**AGENDA
PLANNING & ZONING BOARD
SEPTEMBER 20, 2018
6:00PM**

WESTMINSTER PINE RIDGE ROADWAY & UTILITY DEVELOPMENT CONSTRUCTION PLANS CITY OF FRUITLAND PARK, FLORIDA

APPENDIX B

NOTE:
CONTRACTOR TO PROVIDE A MINIMUM OF 3 FEET OF COVER OVER PROPOSED 6" F.M.

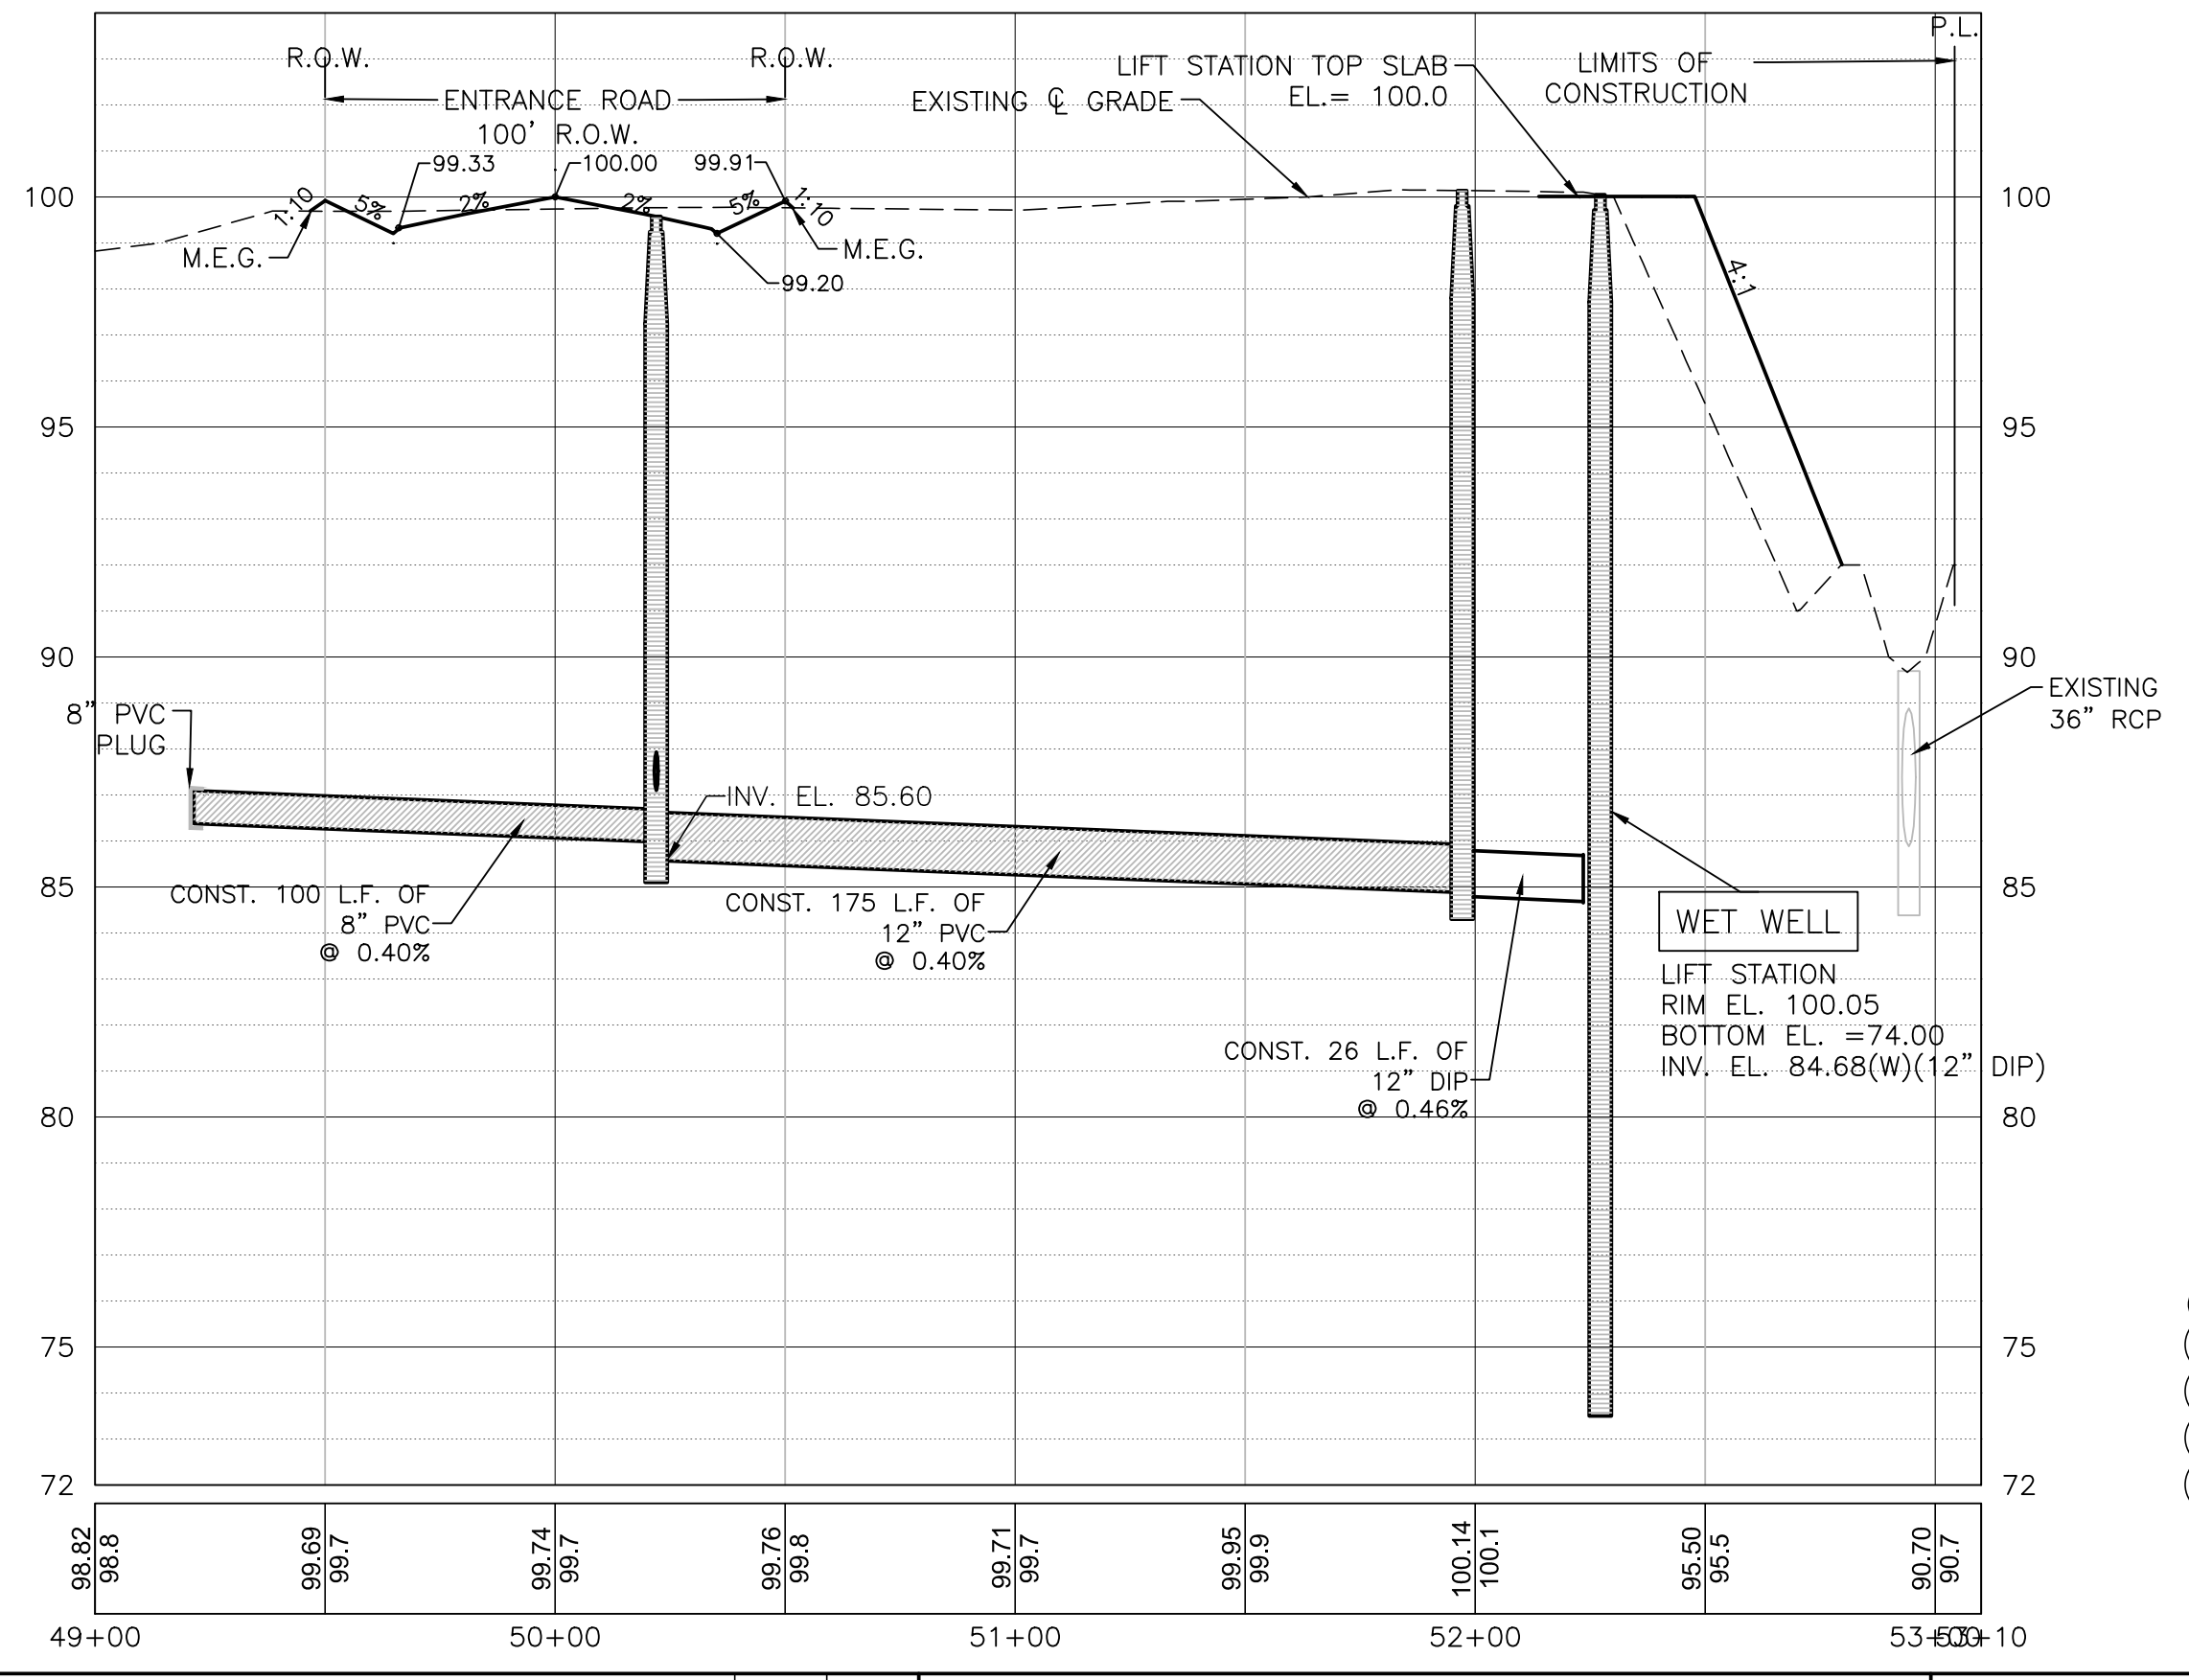
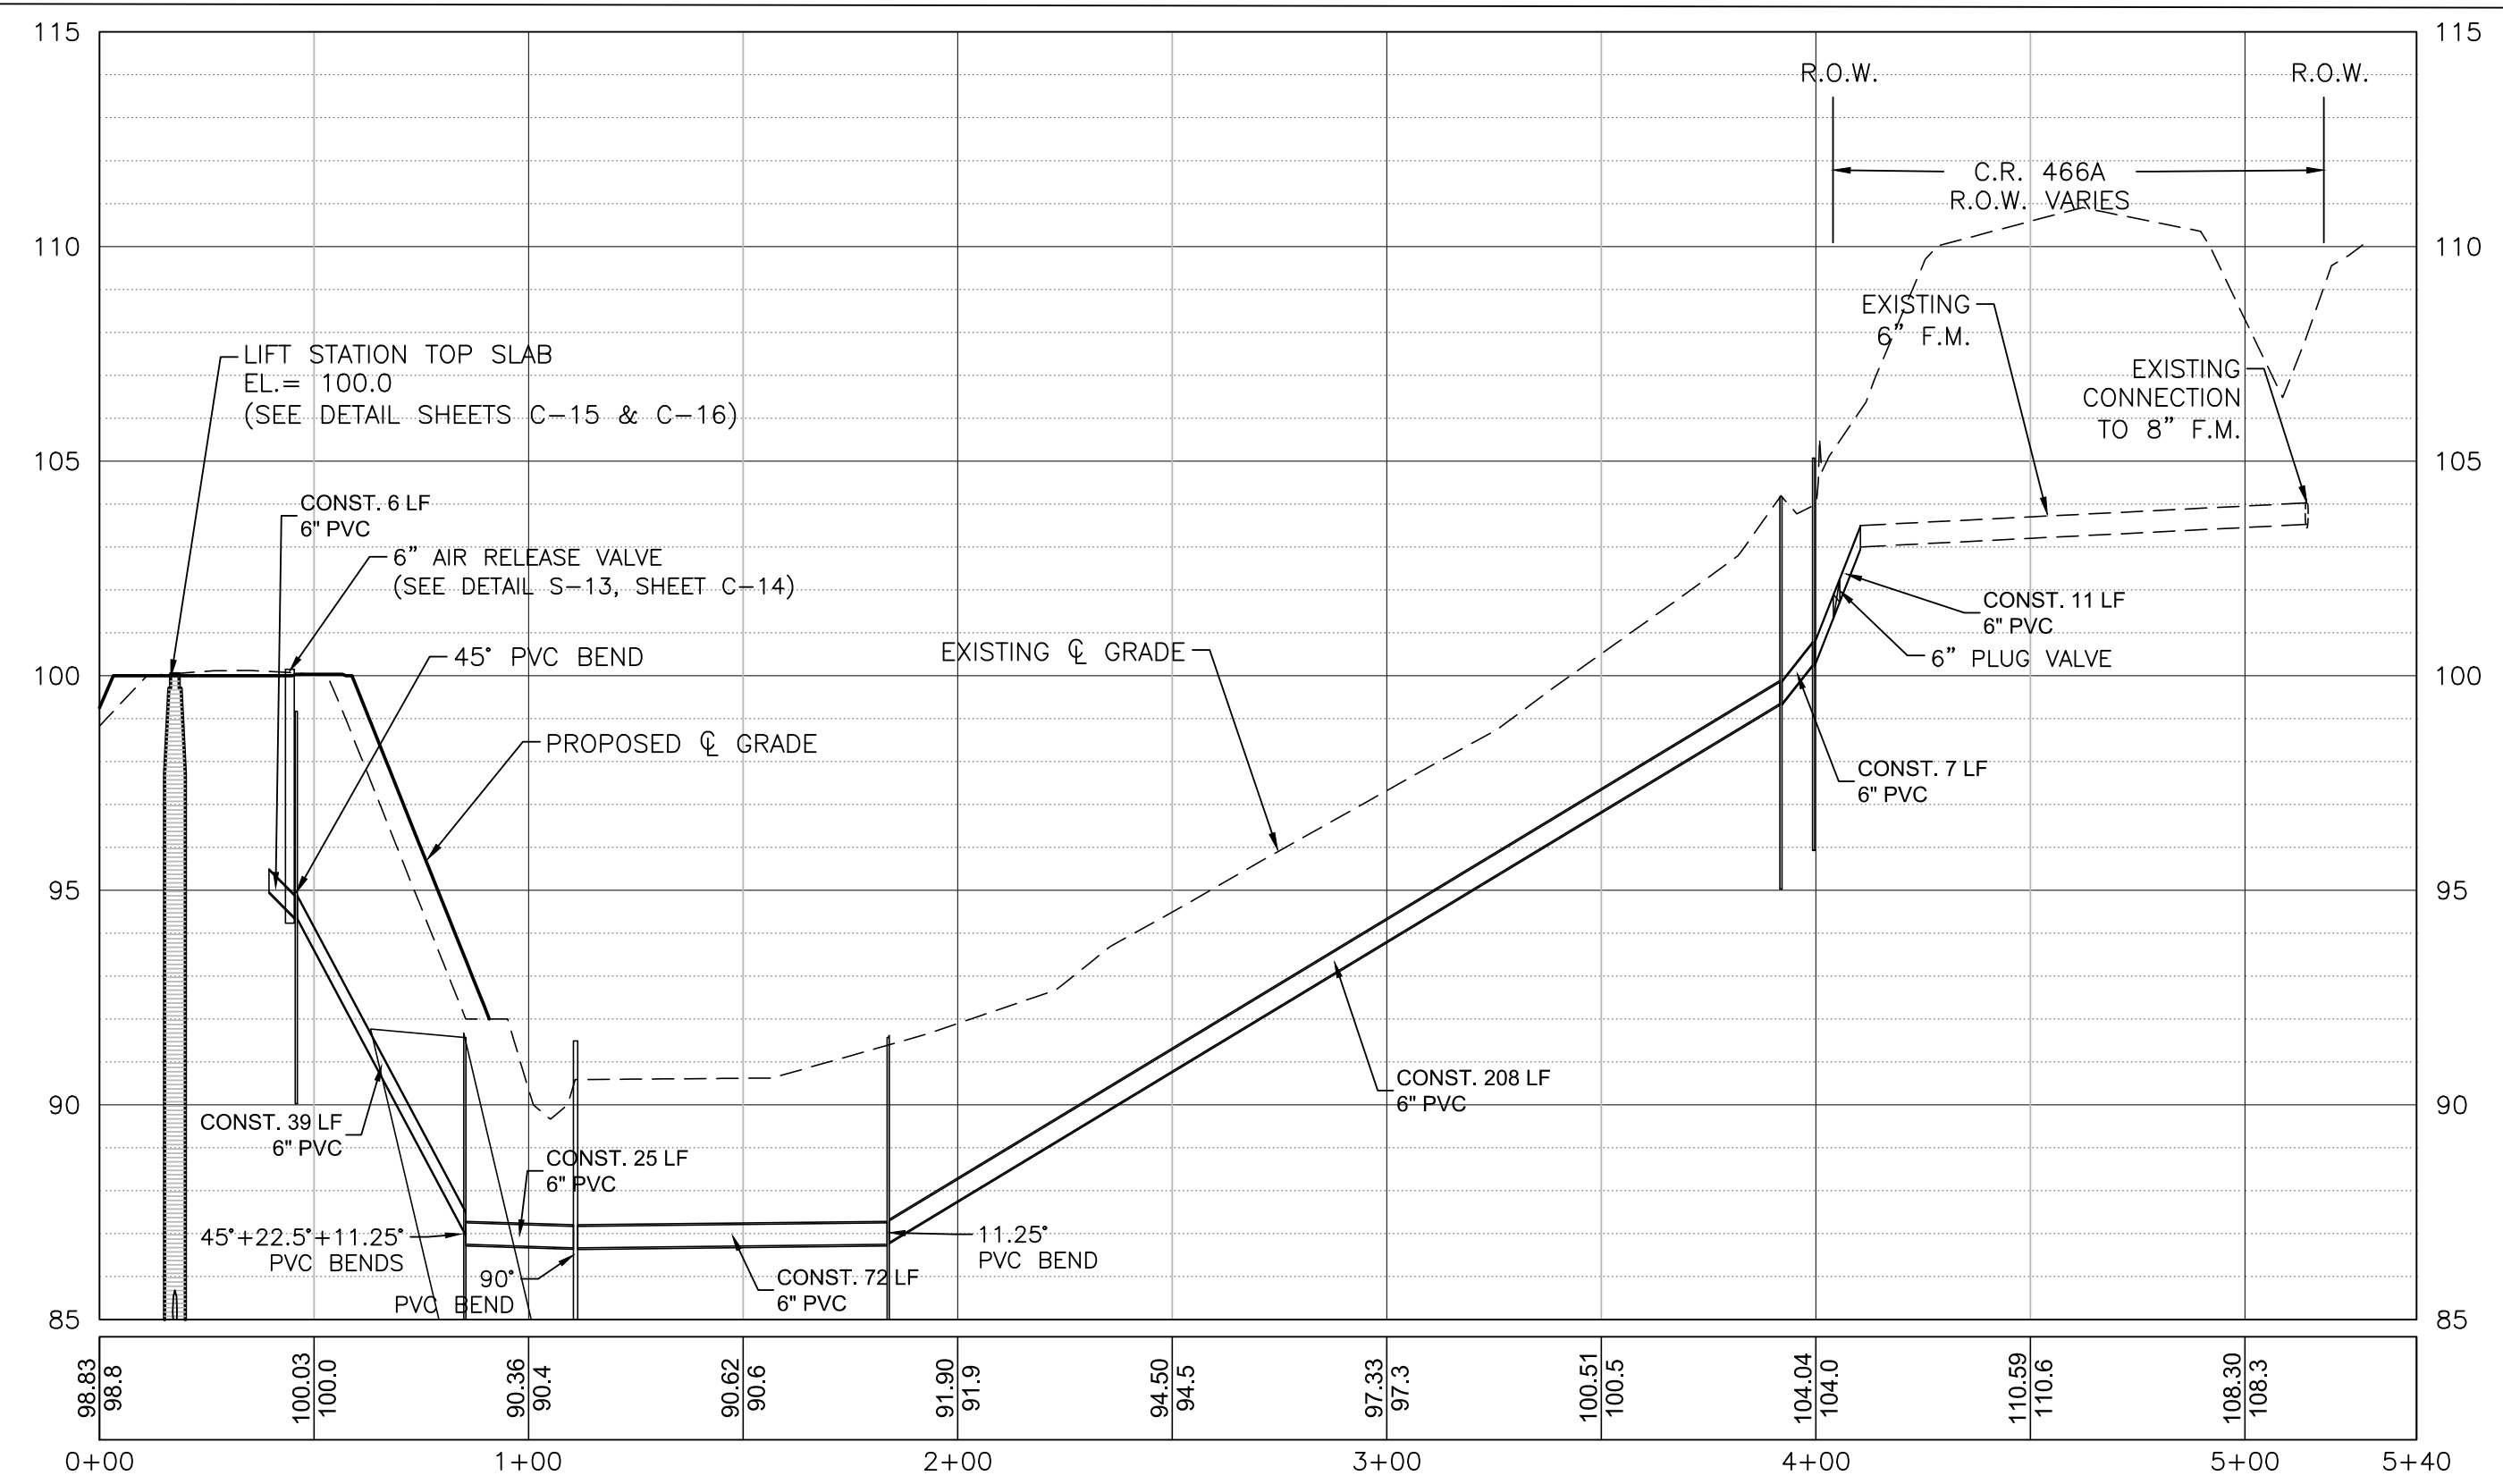
11. Sheet C-11 – Install a plug valve on the proposed force main at the right-of-way line.

12. Sheet C-10 and C-11 – Add a note that proposed utilities and lift station are to be privately owned.

Response: A plug valve has been added on the proposed force main on sheet C-11 as directed.

Response: A note has been added on sheets C-10 and C-11 as directed.
